DEPARTMENT OF PUBLIC WORKS
CITY AND COUNTY OF HONOLULU

TECHNICAL SOLUTION FOR POTENTIAL FLOODING IN
THE KALOI GULCH DRAINAGE BASIN

KALOI GULCH
EXHIBIT A

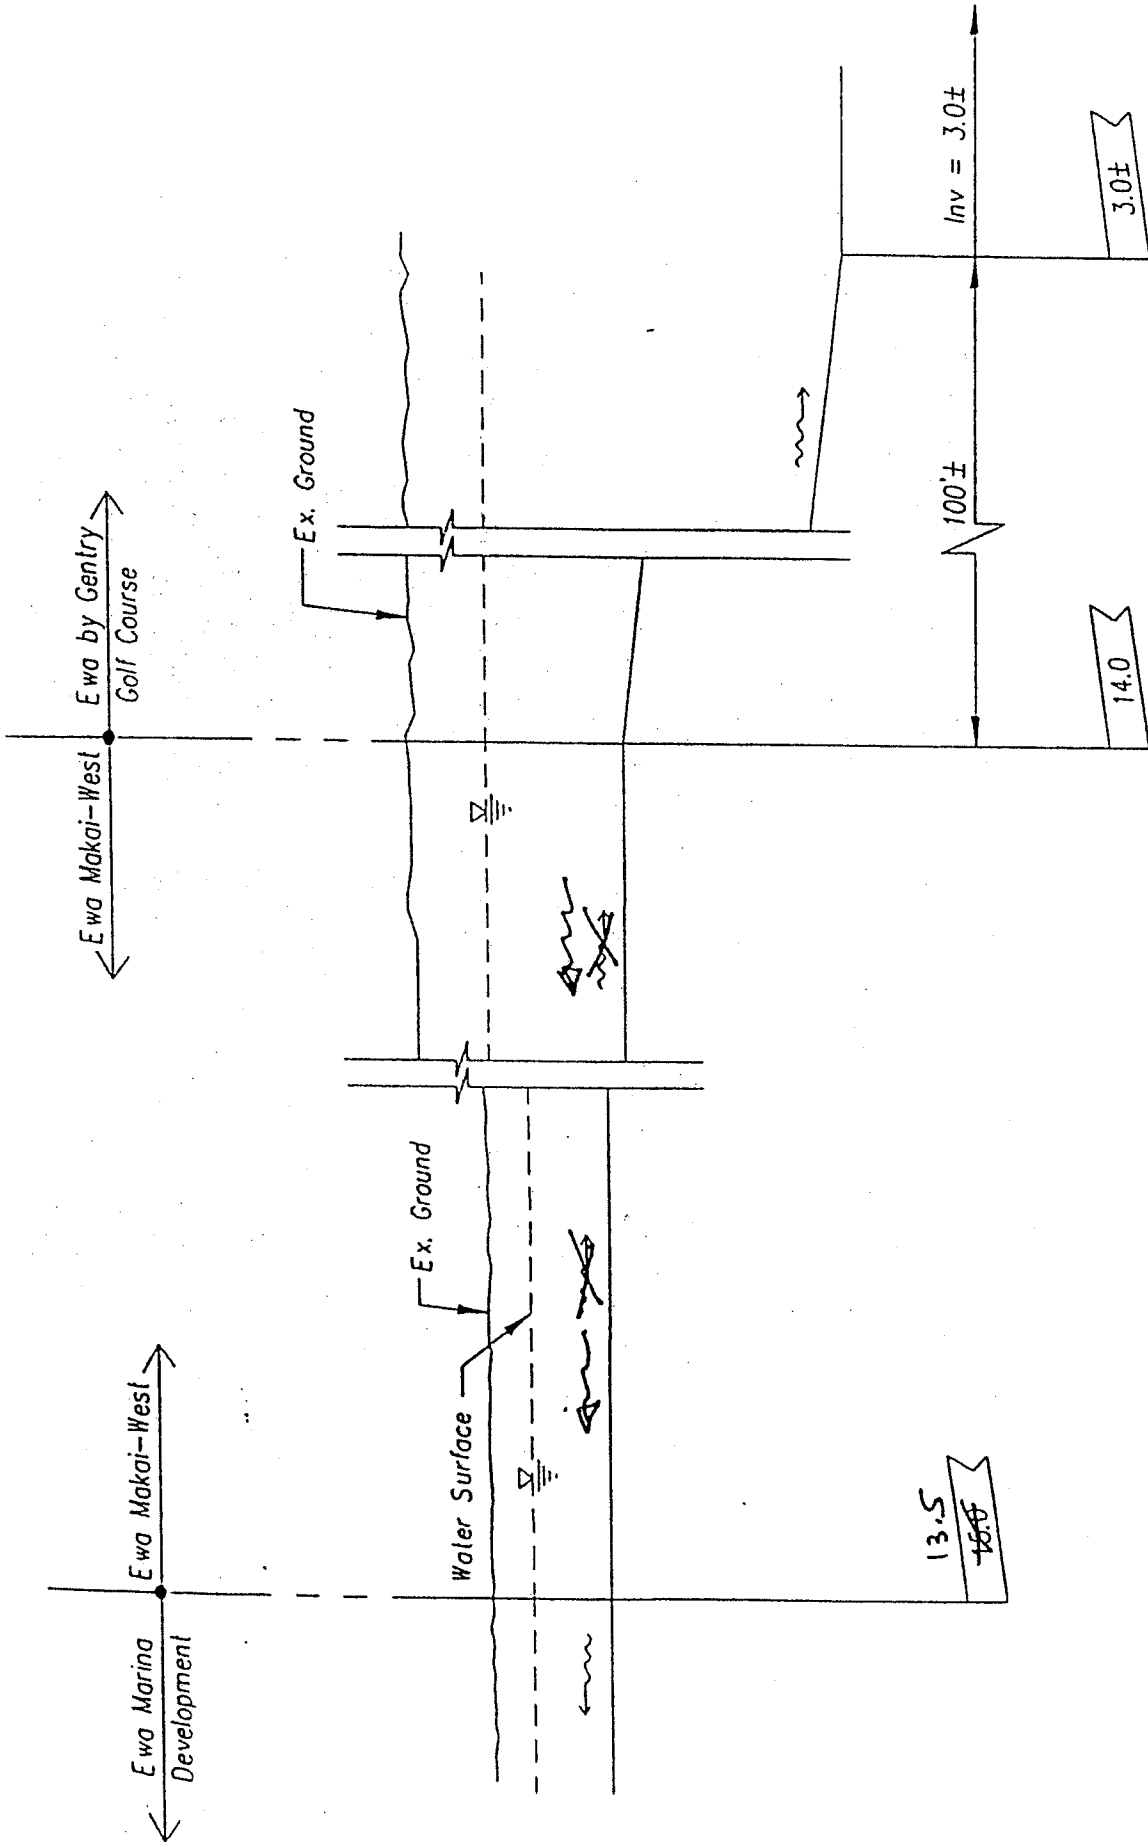
- 4) The channel invert at the Haseko/Ewa-Makai West interface will be set at an elevation of ¹³~~15~~ feet. The channel within Haseko's property shall be designed to convey 1,200 cfs with freeboard capacity of 2,500 cfs and maintaining a hydraulic grade line of ¹³~~15~~ feet as shown in Exhibit A.

- 5) The channel invert at the Ewa-Makai West/ Gentry interface will be set at an elevation of 14 feet. The channel within Ewa-Makai West property shall be designed to convey 1,200 cfs with a freeboard capacity of 2,500 cfs as shown in Exhibits A and B. Any modifications to the channel will require the approval of all parties involved in this agreement.

- Items C.4 and C.5, inverts of 15 feet at the Haseko/Ewa Makai-West boundary and 14 feet at the Ewa Makai-West/Gentry boundary. These inverts were offered as a compromise between disagreeing parties. We feel, however, that the invert at the Haseko/Ewa Makai-West boundary could and should be lower than 14 feet and closer to the ultimate channel invert of 12 feet. Design of the resulting channel could still be restricted to the indicated flows. The channel with the lower invert at the Haseko/Ewa Makai-West boundary would be narrower and cheaper than the wider, shallower channel proposed in Exhibits A and B. The restrictive inverts proposed in C.4 and C.5 does not appear to provide benefits to any of the developments, and only serves to increase the construction cost of this interim channel.
